Approved Section: 4.55(1A) Application No: SSD-6339-Mod-3
Granted: 7 June 2021 Signed: *[Signature]*
Sheet no: 1 of 19

MODIFICATION APPLICATION

TITLE	
LEVEL 3 - PHASE A (REVISED PLAN)

PROJECT	
RPAC	
26 ALBION STREET WAVERLEY NSW 2024

LEVEL 5 - PHASE B (REVISED PLAN)

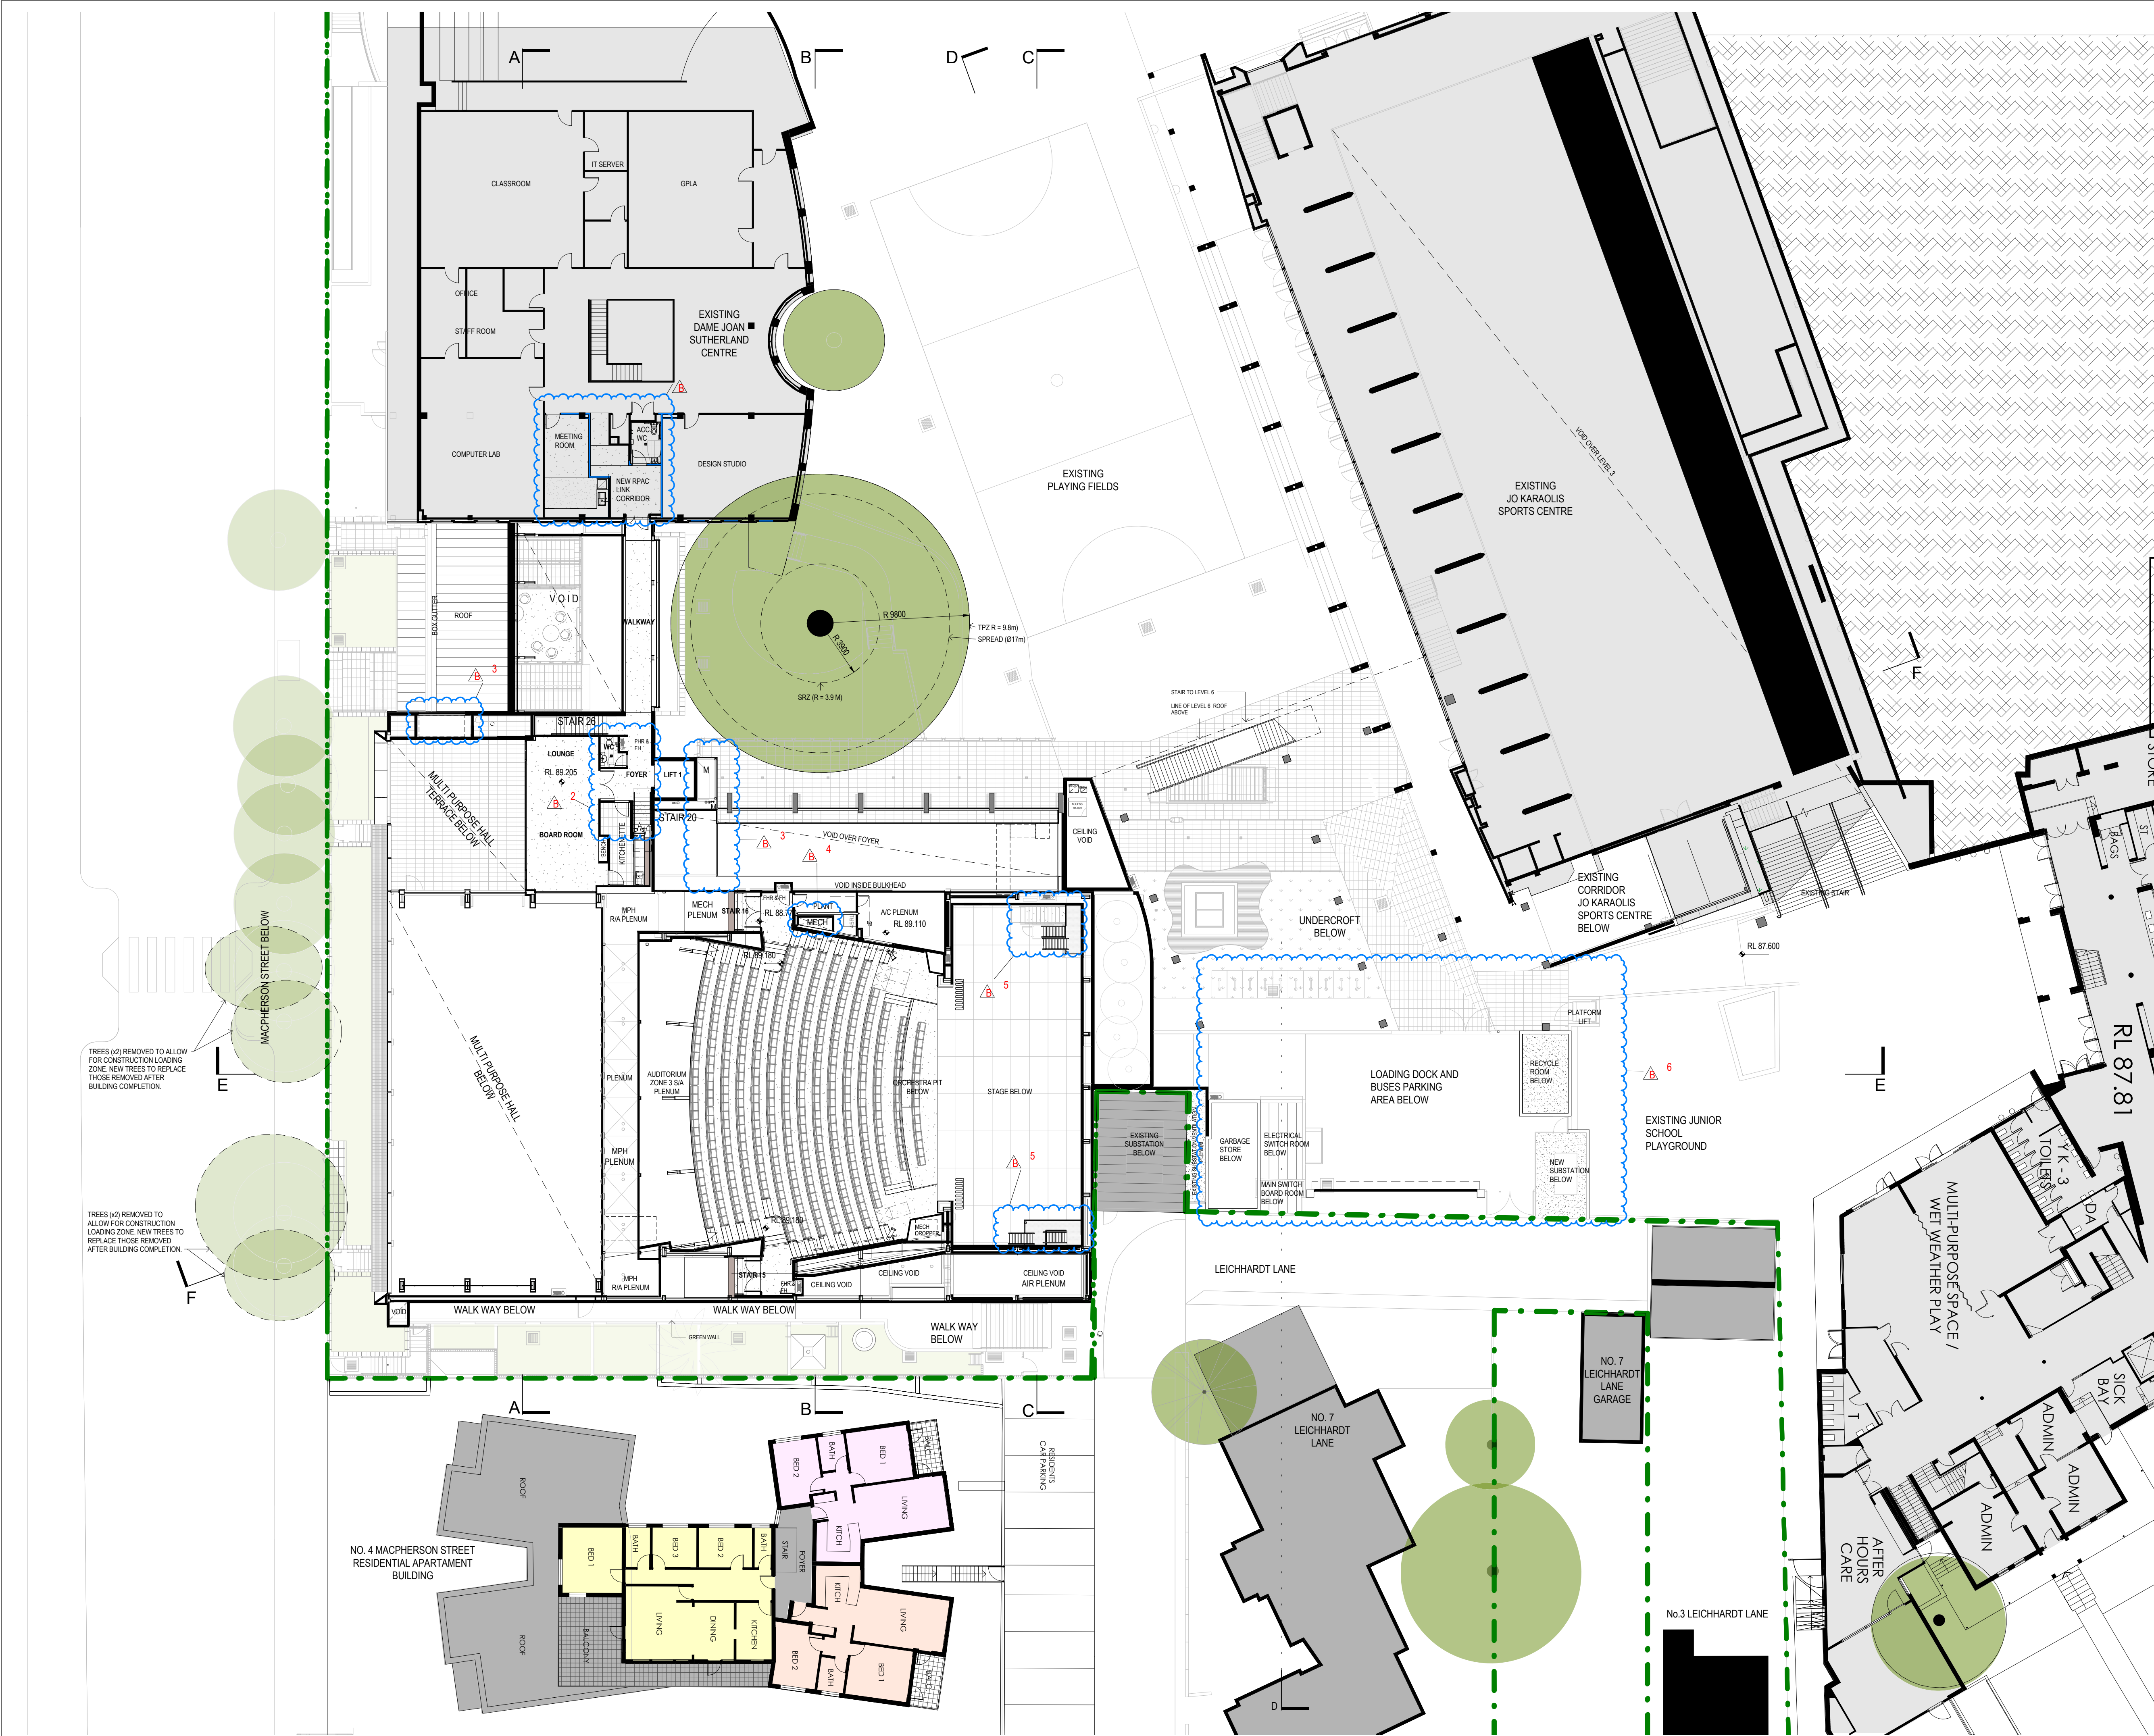
- LIST OF CHANGES LEVEL 5:
1. MEETING ROOM, CORRIDOR, AND STORE LAYOUT REVISED TO INCLUDE ACCESSIBLE BATHROOM TO SERVICE RPAC LEVEL 5 AND EXISTING DAME JOAN SUTHERLAND CENTRE FOR ACCESSIBILITY COMPLIANCE.
 2. REVISED LEVEL 5 LIFT CORRIDOR AND ADJACENT ROOMS LAYOUT FOR ACCESSIBILITY COMPLIANCE.
 3. SERVICES RISER AND CEILING CAVITY REVISED FOR SERVICES RETICULATION
 4. NEW MECHANICAL PLENUM INCLUDED FOR SERVICES RETICULATION
 5. REVISED VERTICAL ACCESS ARRANGEMENT TO THE STAGE CATWALKS FOR COMPLIANCE AND IMPROVED FUNCTIONALITY.
 6. NEW SUBSTATION LOCATION AND REVISED SERVICE VEHICLE ZONE IN LEVEL 4 (LEVEL BELOW)

LEVEL 7 - PHASE A (REVISED PLAN)

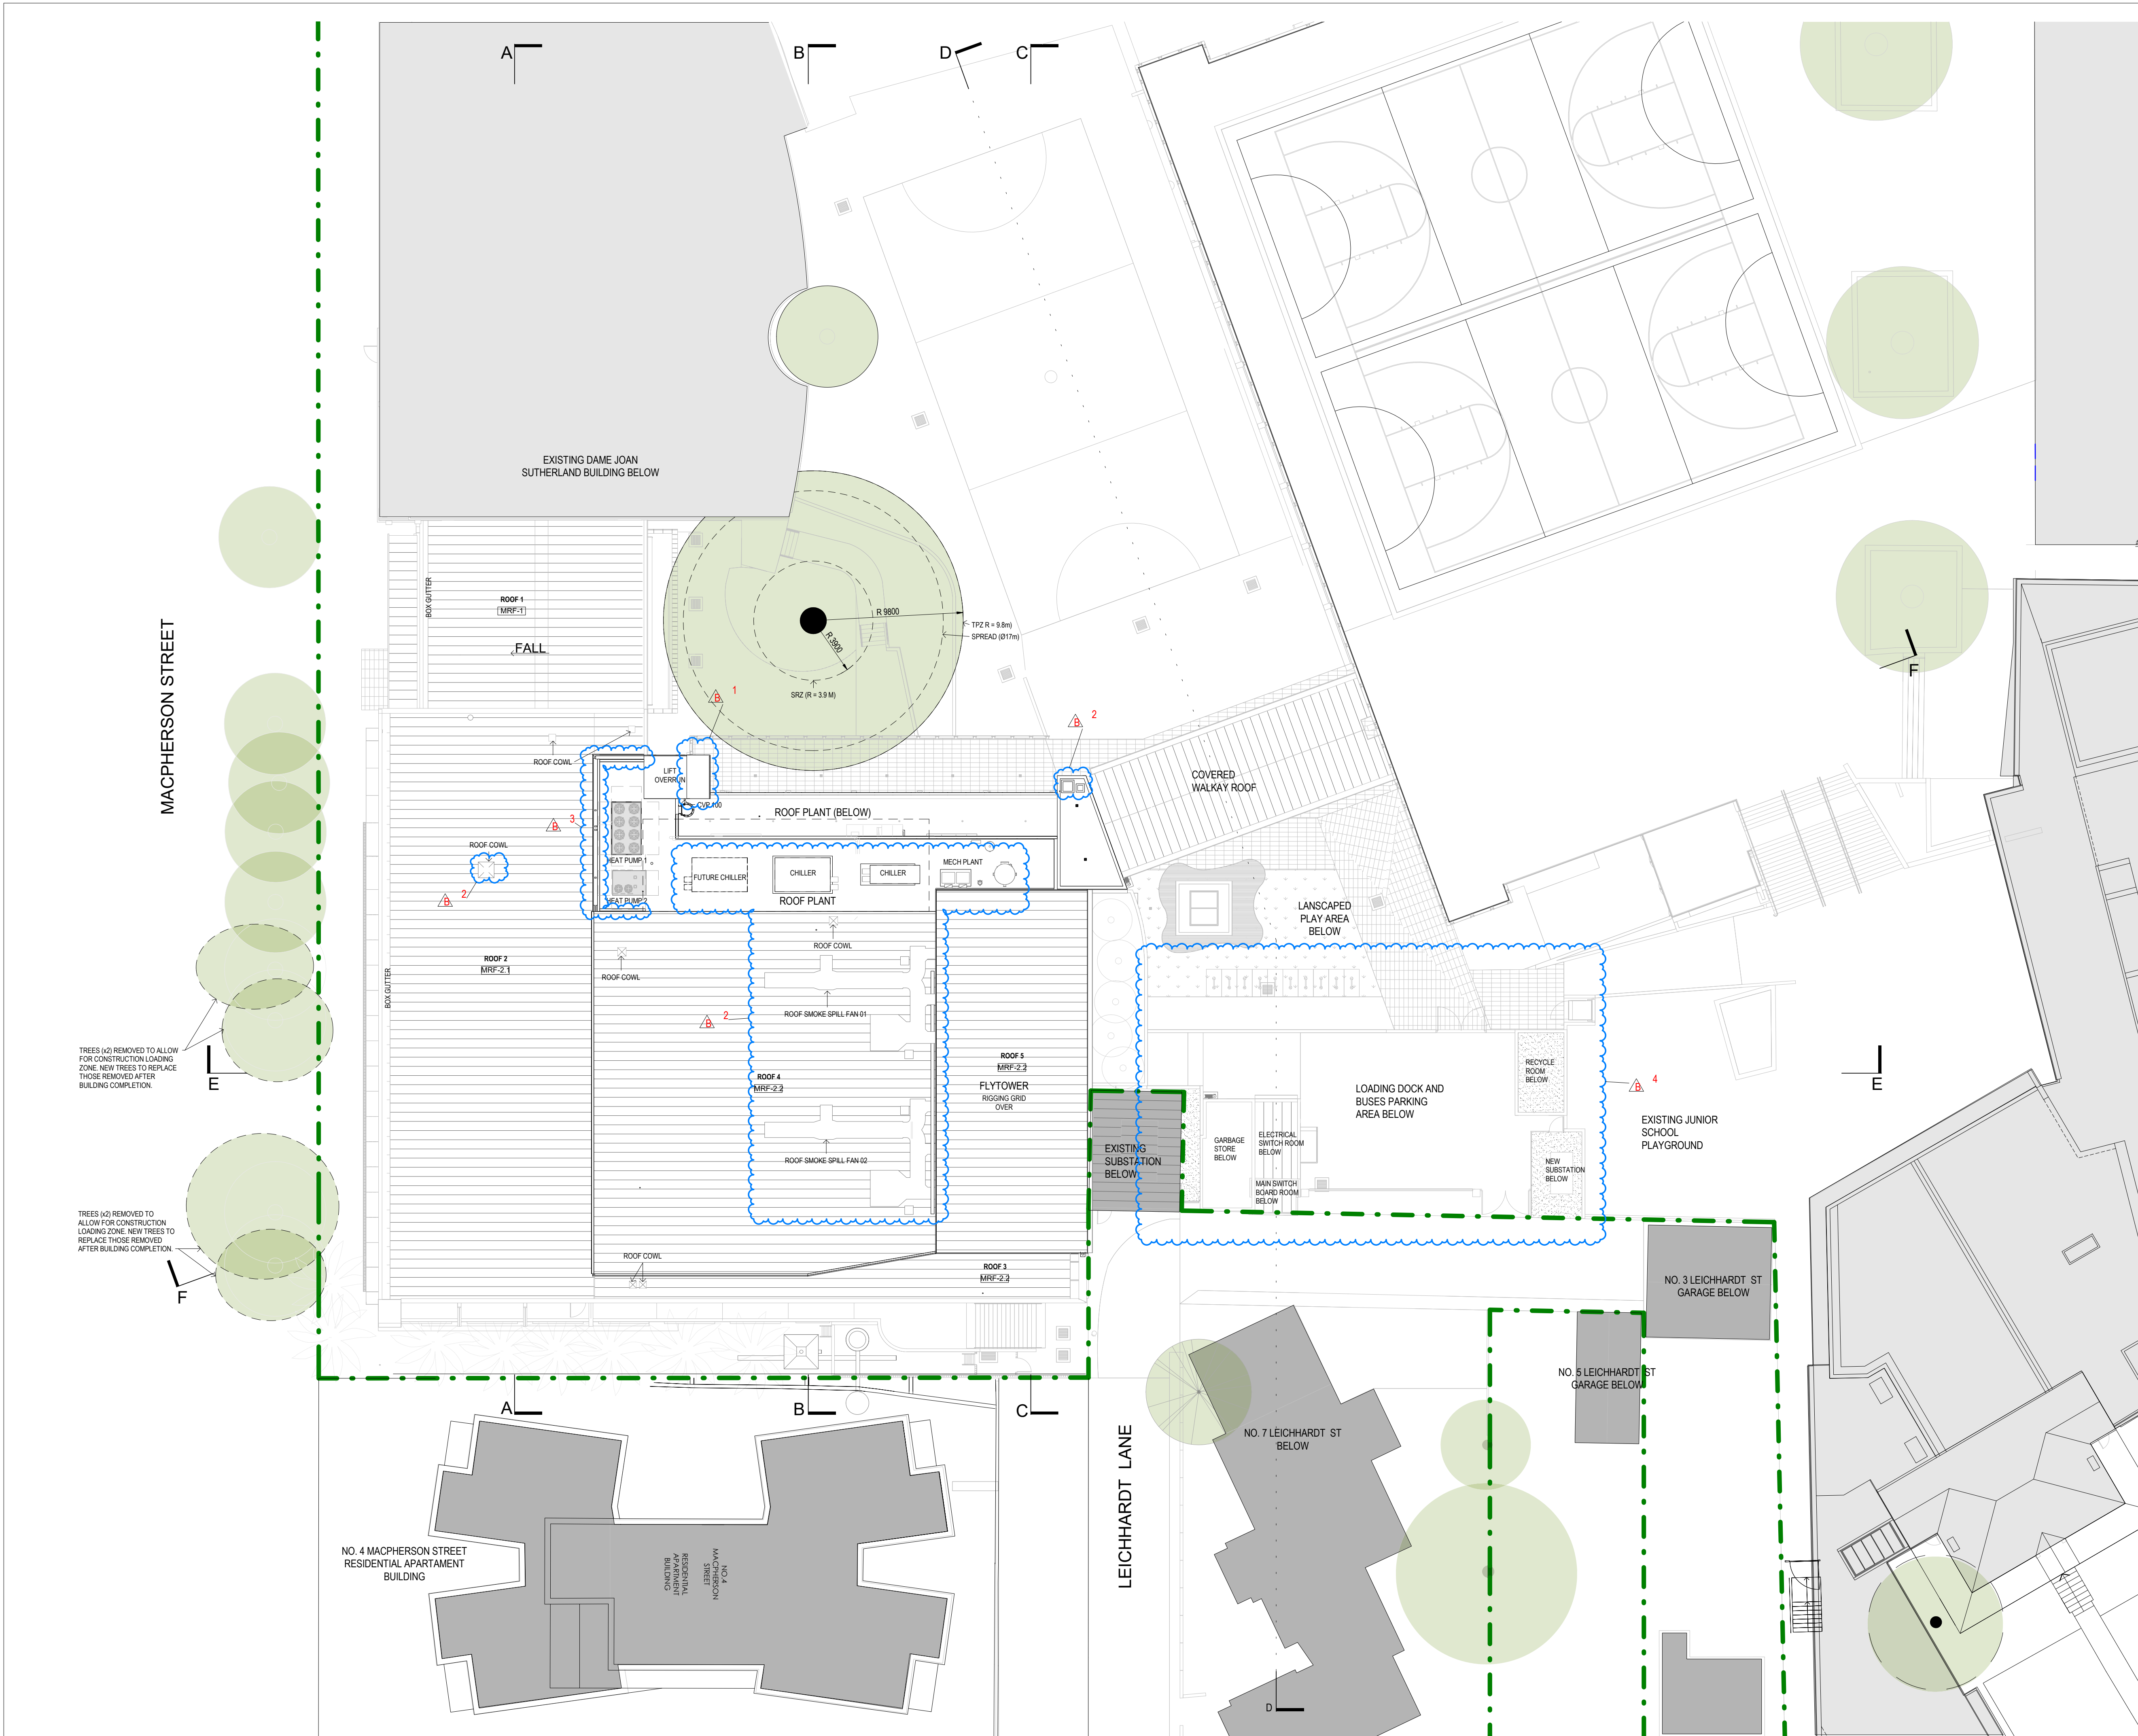
LIST OF CHANGES LEVEL 7:

1. REVISED RISER SIZE FOR SERVICES RETICULATION.
2. MECHANICAL SERVICES AT ROOF PLANT AND ROOF LEVEL UPDATED TO REFLECT FINAL DESIGN.
3. SCREENING TO PLANT FOR COMPLIANCE WITH CONDITIONS OF CONSENT.
4. NEW SUBSTATION LOCATION AND REVISED SERVICE VEHICLE ZONE IN LEVEL 4 (LEVEL BELOW).

LEVEL 6 - PHASE A (REVISED PLAN)

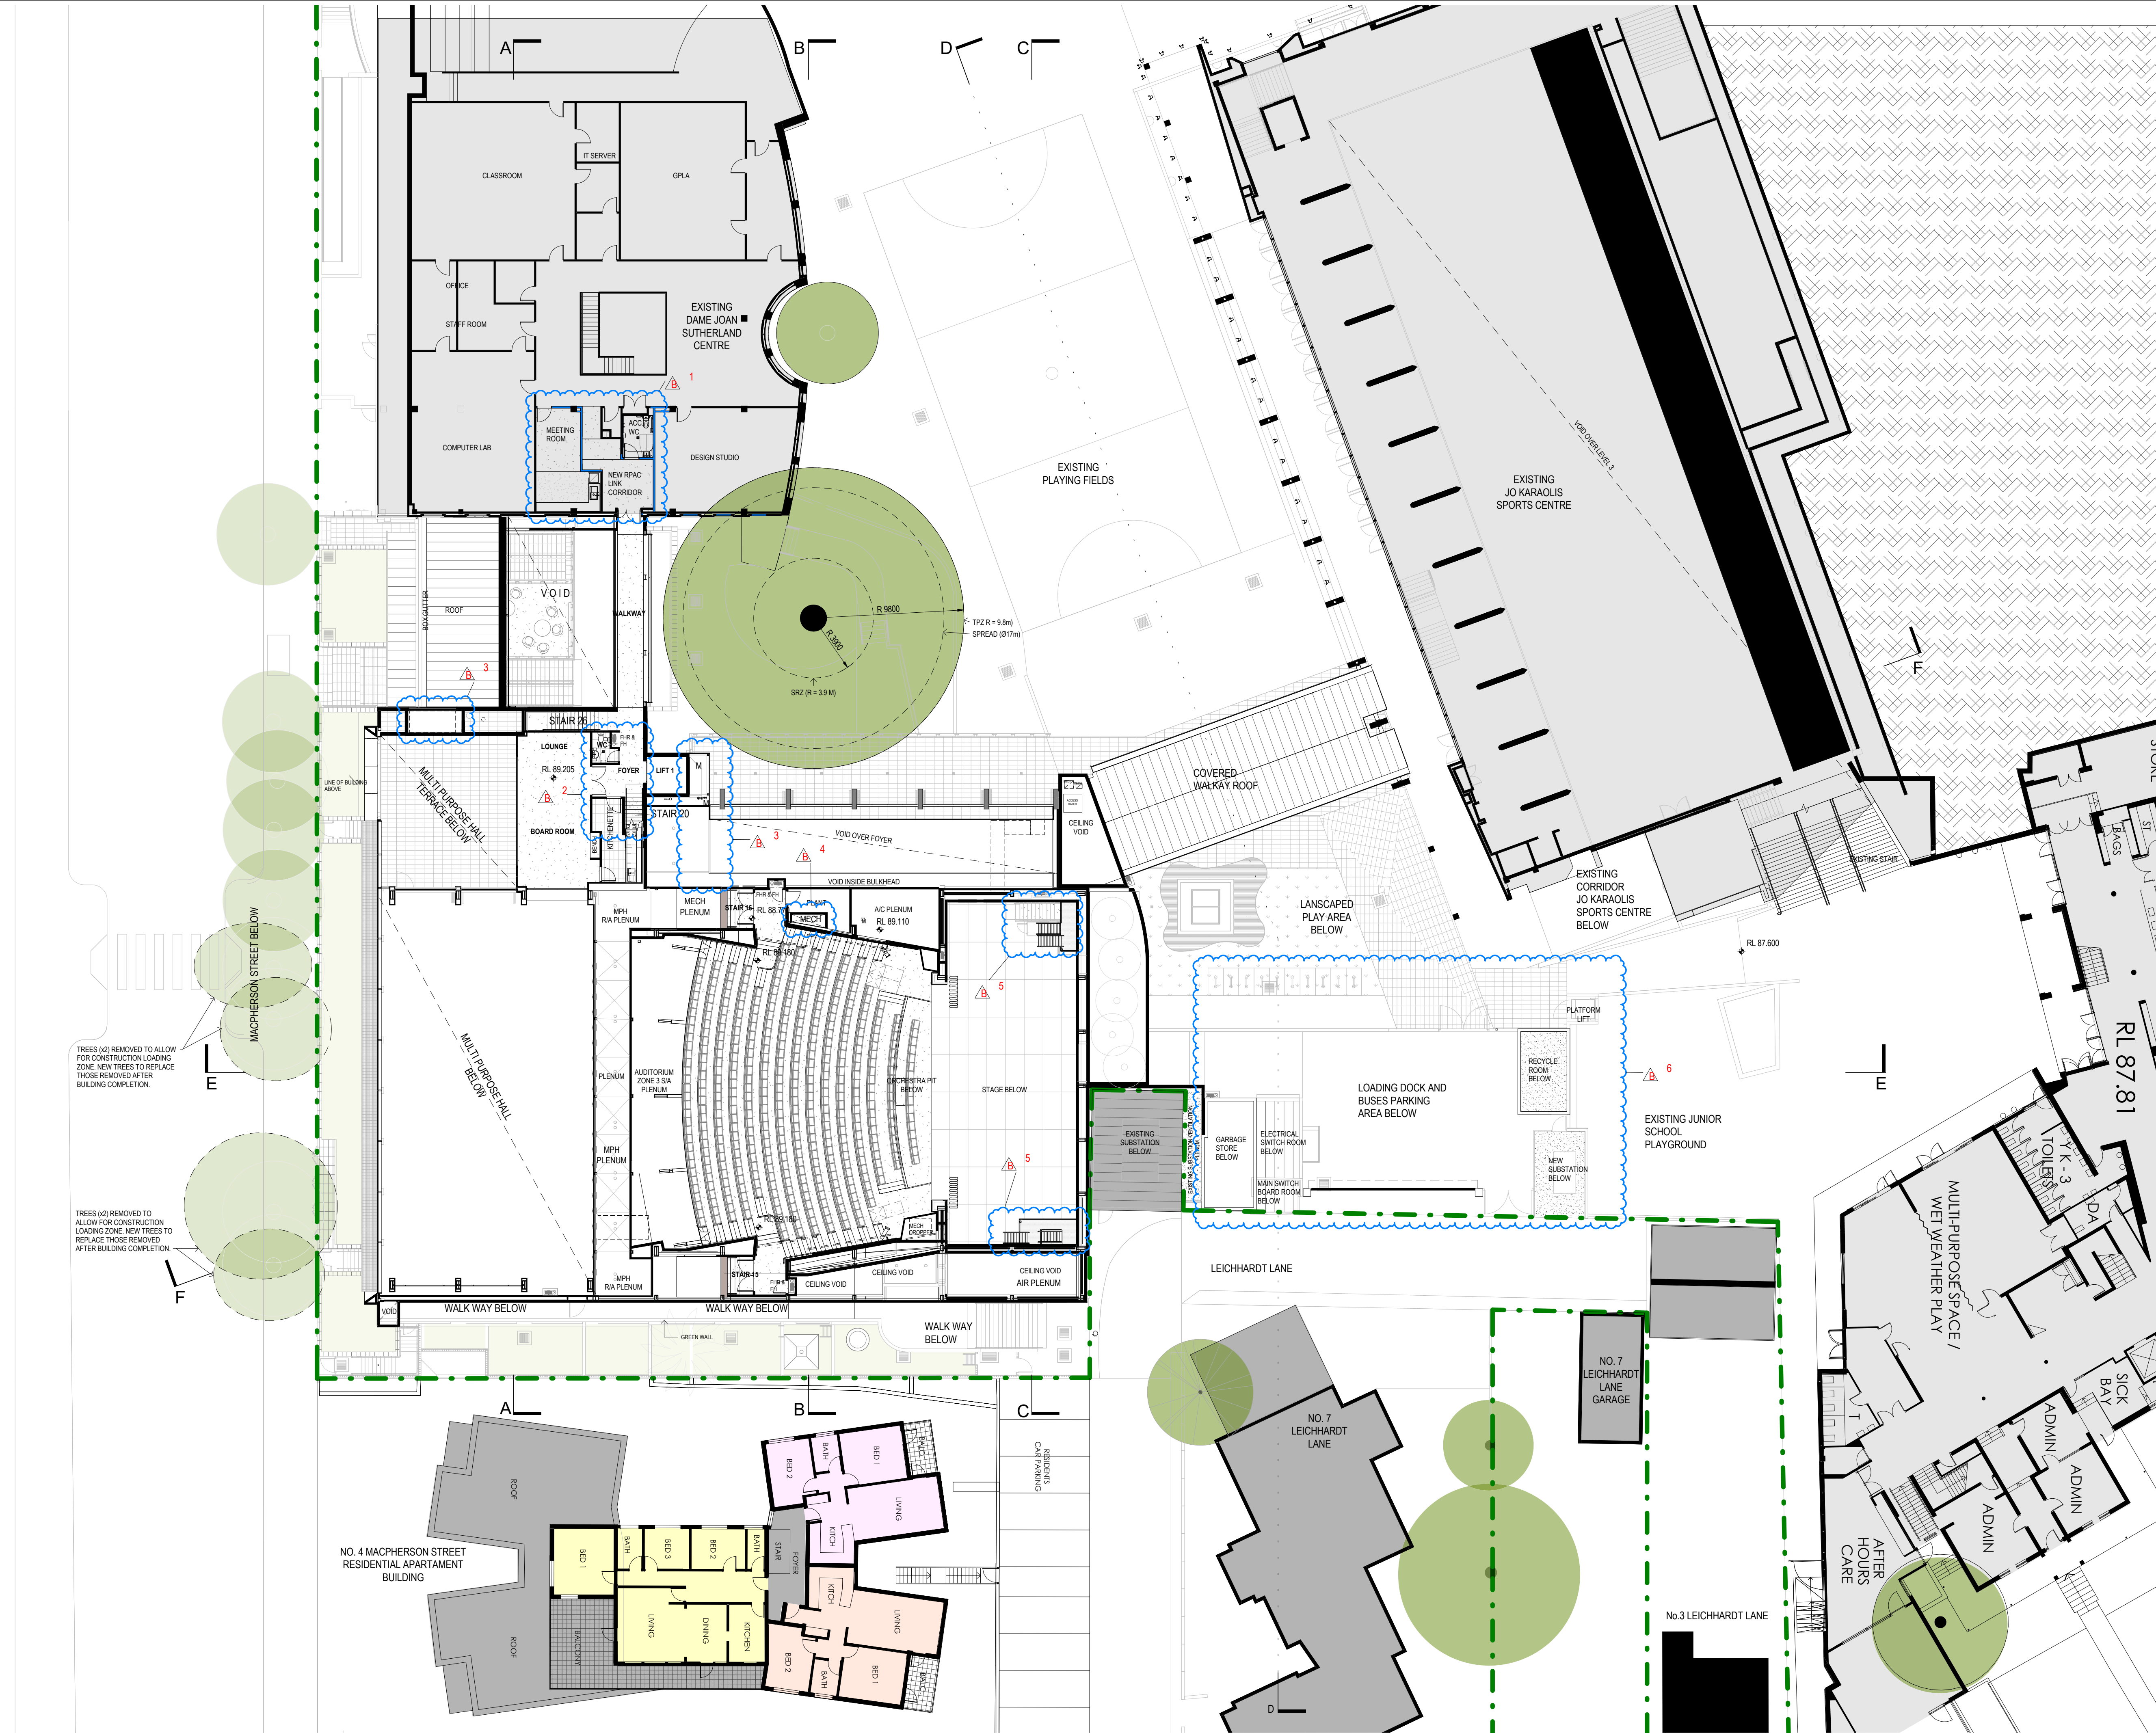
- LIST OF CHANGES LEVEL 6:
1. REVISED DOOR LOCATIONS FOR CORRIDOR AND PLANT AREA FOR FIRE SEPARATION AND EGRESS COMPLIANCE.
 2. REVISED RISER SIZE FOR SERVICES RETICULATION.
 3. NEW MECHANICAL PLENUM INCLUDED FOR SERVICES RETICULATION
 4. REVISED VERTICAL ACCESS ARRANGEMENT TO STAGE CATWALKS FOR COMPLIANCE AND IMPROVED STAGE OPERATION FUNCTIONALITY.
 5. NEW SUBSTATION LOCATION AND REVISED SERVICE VEHICLE ZONE IN LEVEL 4 (LEVEL BELOW)
